Access Compliance Report

Public Rights-of-Way

(Curb Ramps)

Intersection ID: 32250	Main Street: DARCY_HOPKINS_DR	Cross Street: DENNINGTON_GROVE_LN	Location: W
ADA ID: B8F8B539673C	Ramp Type: PerpDiag	Initial Pass/Fail: Fail	Overall Compliance: No
Severity Score: 22.5			
Codes/Mitigation Info/Possible Solution		Field Measurements/Component Compliance

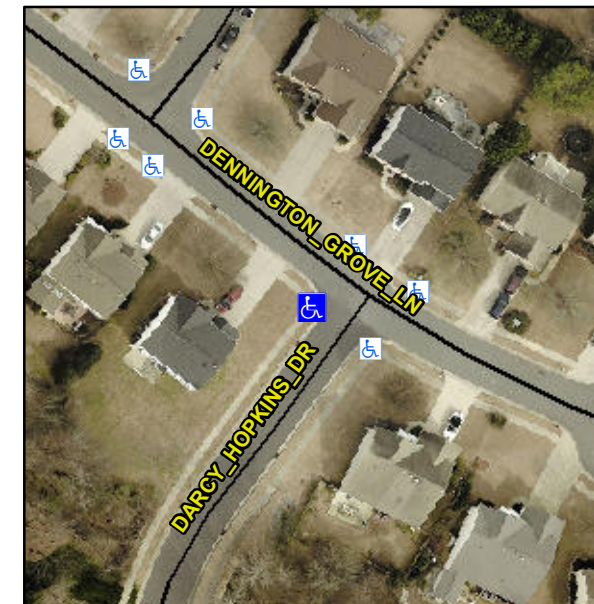
Not Found, R304.5.1, R304.2.2, R304.5.3

Compliance	Description	Data	Compliance	Description	Data
N/A	Ramp Length (in)	99.0	No	Ramp Slope (%)	8.5
No	Ramp Width (in)	46.0	No	Ramp XSlope (%)	2.6
N/A	Flare Type LT	N/A	N/A	Flare Type RT	N/A
N/A	Flare Slope LT (%)	N/A	N/A	Flare Slope RT (%)	N/A
N/A	Flare Traversable LT?	N/A	N/A	Flare Traversable RT?	N/A
N/A	Landing Length (in)	N/A	N/A	DWS Provided?	N/A
N/A	Landing Width (in)	N/A	N/A	DWS Contrast?	N/A
N/A	Landing Slope (%)	N/A	N/A	DWS Length (in)	N/A
N/A	Landing X Slope (%)	N/A	N/A	DWS Full Width?	N/A
N/A	Landing Curb? (Y/N)	N/A	N/A	DWS Offset (in)	N/A
N/A	Shared Landing?	N/A			
N/A	Gutter Ponding?	N/A	N/A	Gutter Slope (%)	N/A
N/A	Gutter Lip Ht (in)	N/A	N/A	Gutter X Slope (%)	N/A
N/A	Painted X Walk1?	No	N/A	Painted X Walk2?	No
	X Walk 1 Direction	To SE		X Walk 2 Direction	To NE
N/A	X Walk 1 Width (in)	N/A	N/A	X Walk 2 Width (in)	N/A
	X Walk 1 Slope (%)	0.0		X Walk 2 Slope (%)	2.1
	X Walk 1 X Slope (%)	3.3		X Walk 2 X Slope (%)	0.4

Remove & Replace Curb Ramp With Two New Directional Ramps or Equivalent.
